Office Action Summary	Application No. 10/615,133	Applicant(s) O'NEILL ET AL.	
	Examiner Troy Chambers	Art Unit 3641

DETAILED ACTION

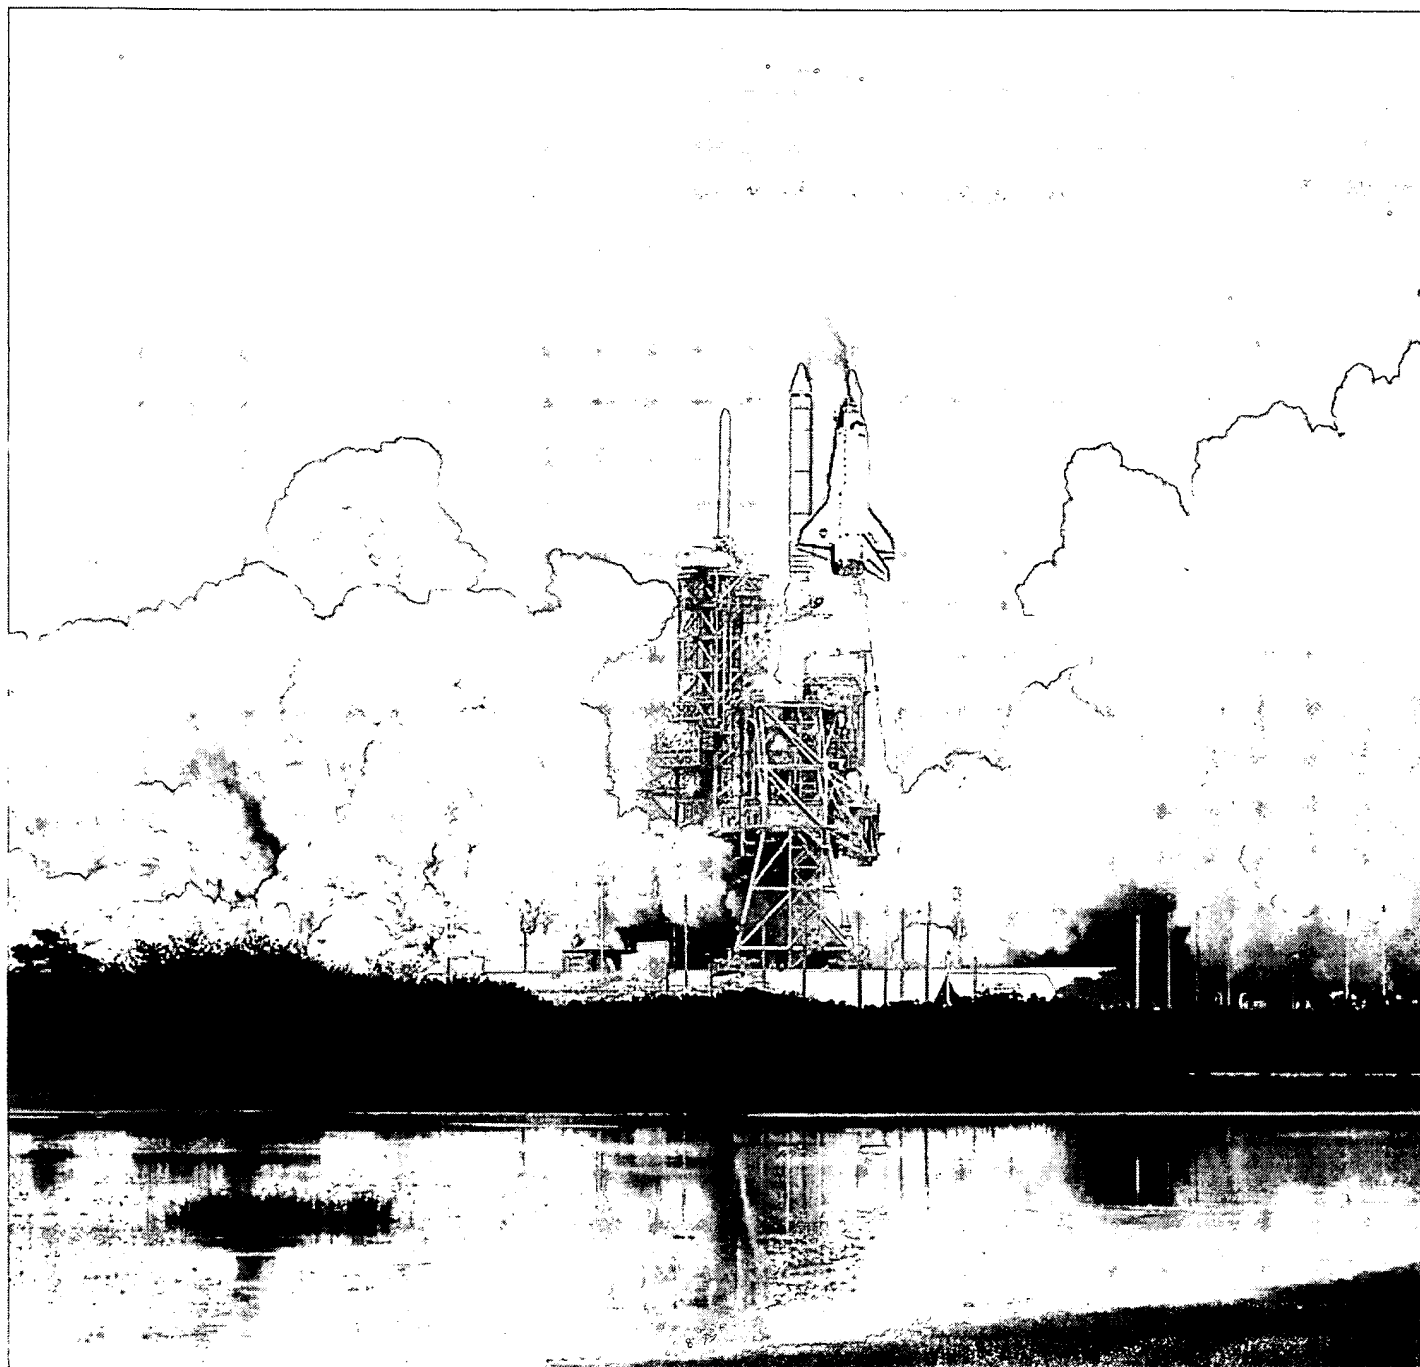
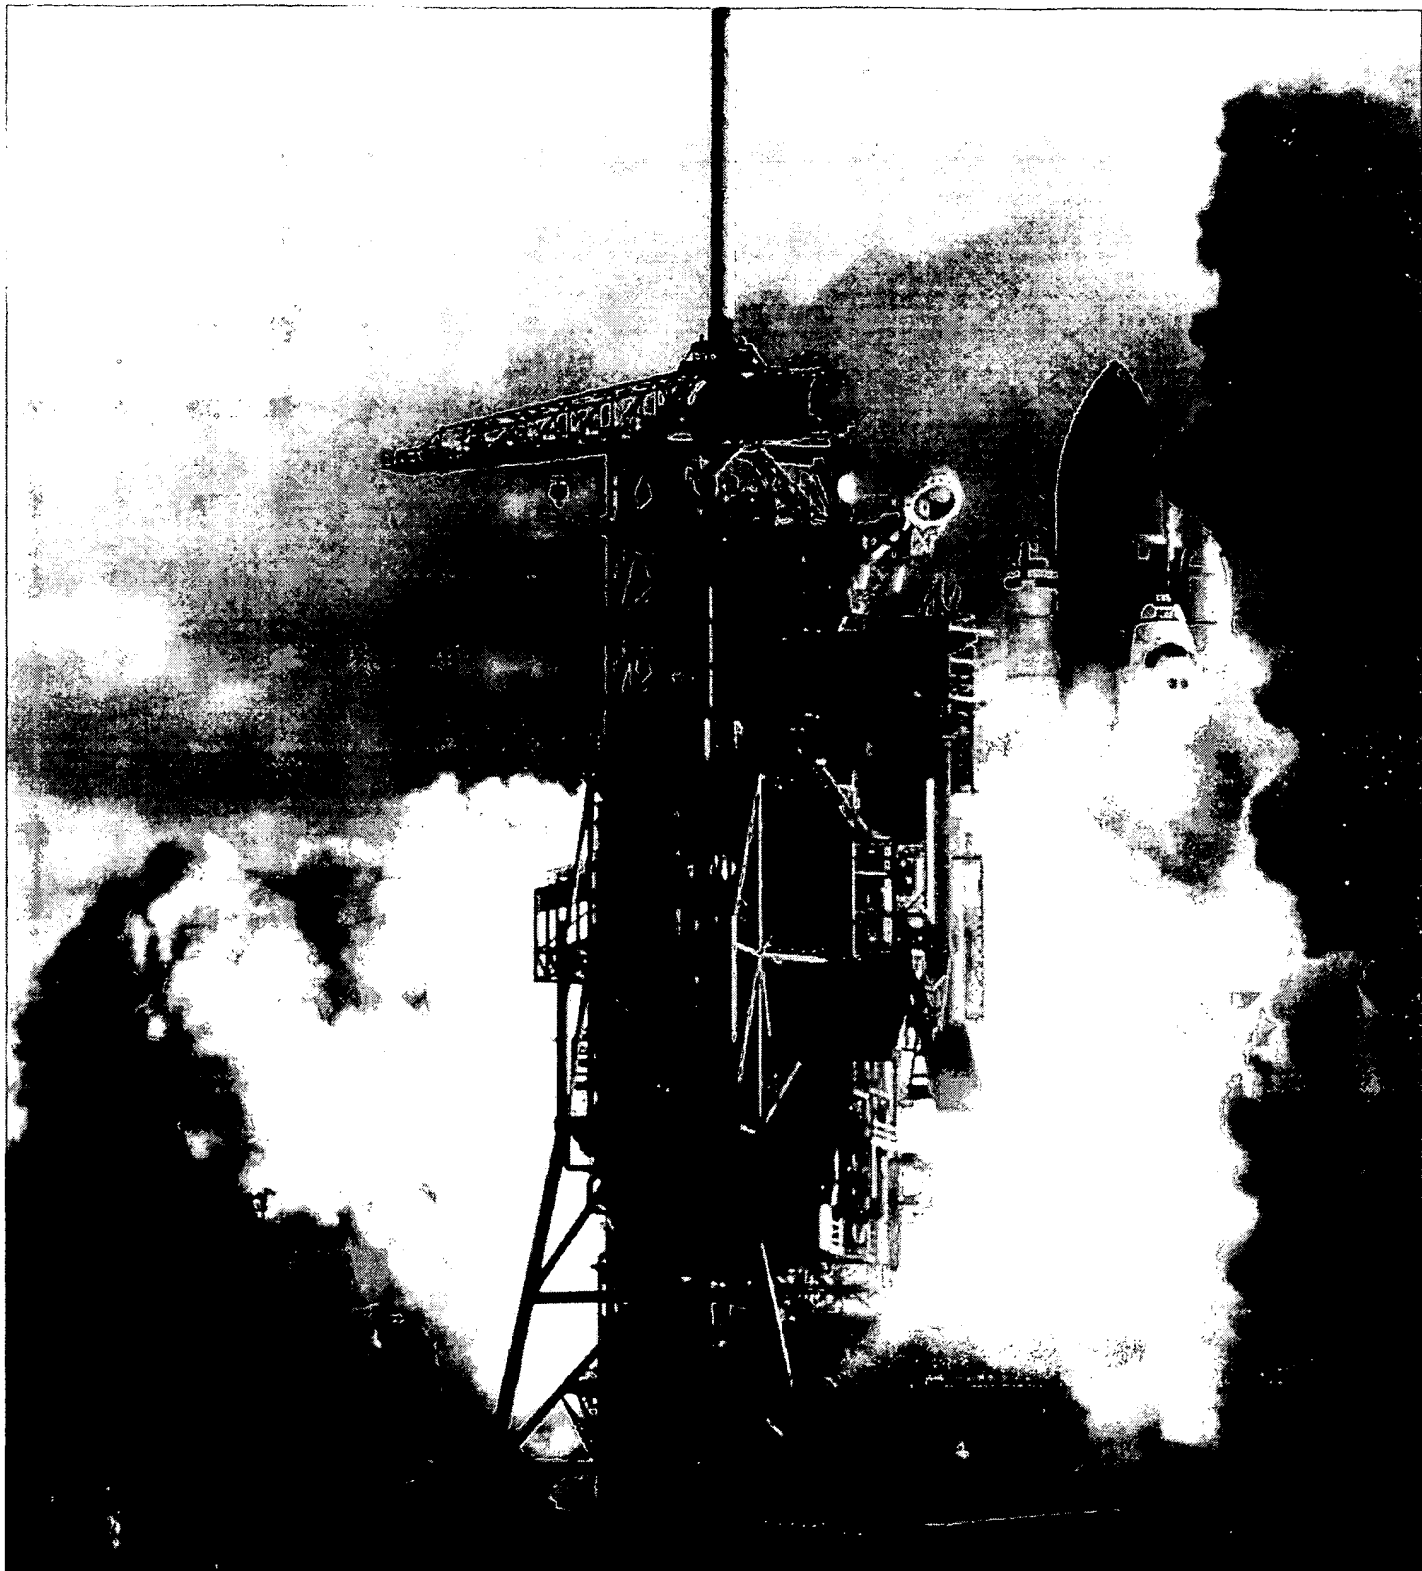
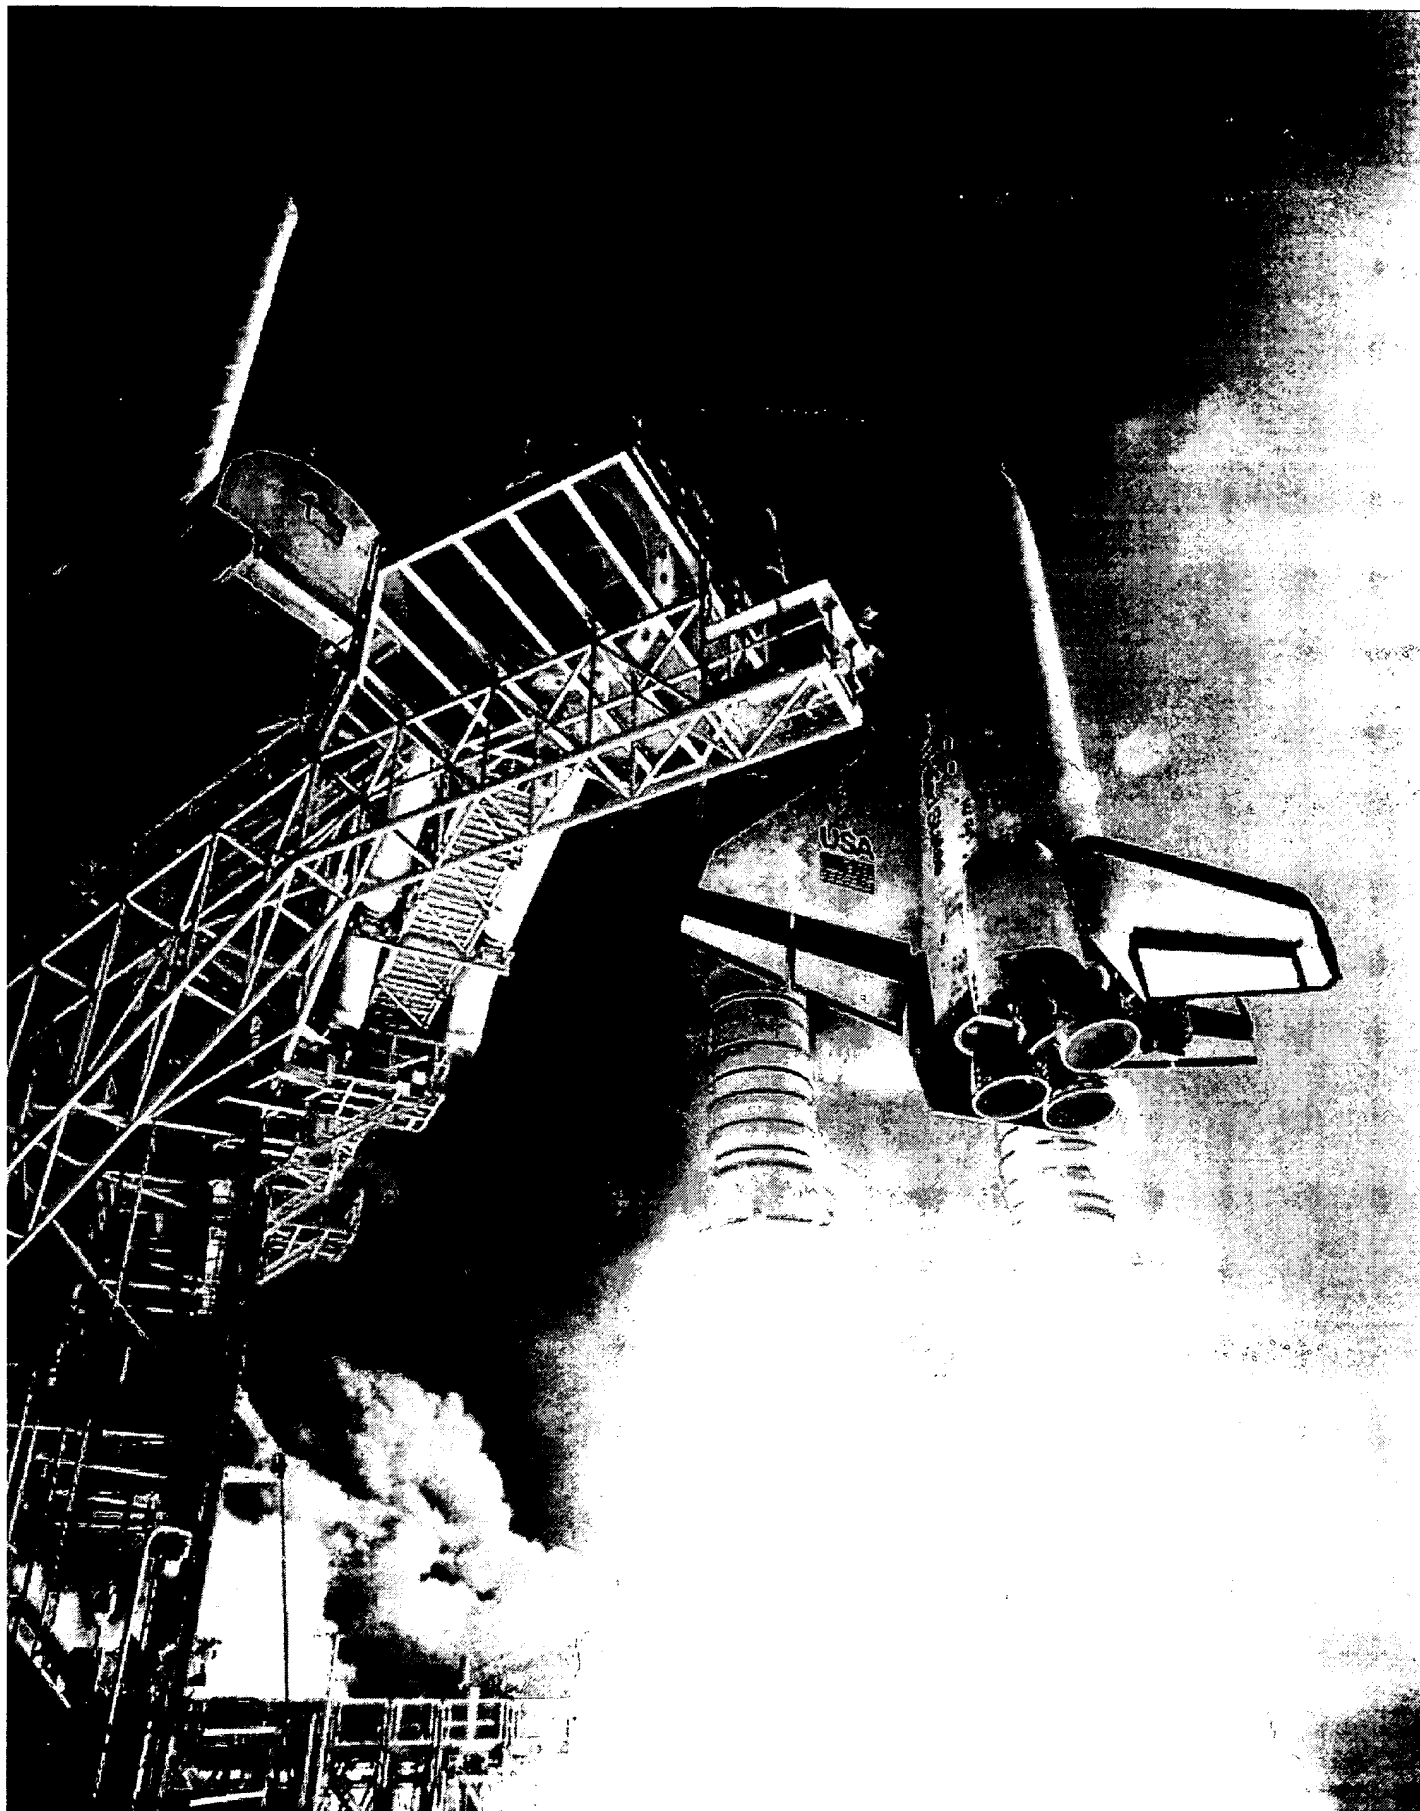
hydrogen, liquid oxygen and solid propellant (See any one of "Space shuttle main engine biography", "Solid Rocket Boosters", "How Space Shuttles Work" and "Space shuttle main engine"). At T minus 0 seconds the SRBs engines ignite the "source" of obscurant comprising solid propellant. As shown in the photos below, the shuttle is riding on a plume having a temperature greater than 150 degrees Celsius and is followed by great clouds of exhaust material, said exhaust inherently including traces of carbon dioxide and water vapor having a temperature less than that of the plume. As shown below, a viewer directly below or to the side of the shuttle during launch would have its view (infrared or otherwise) obscured by the clouds of obscuring agent.
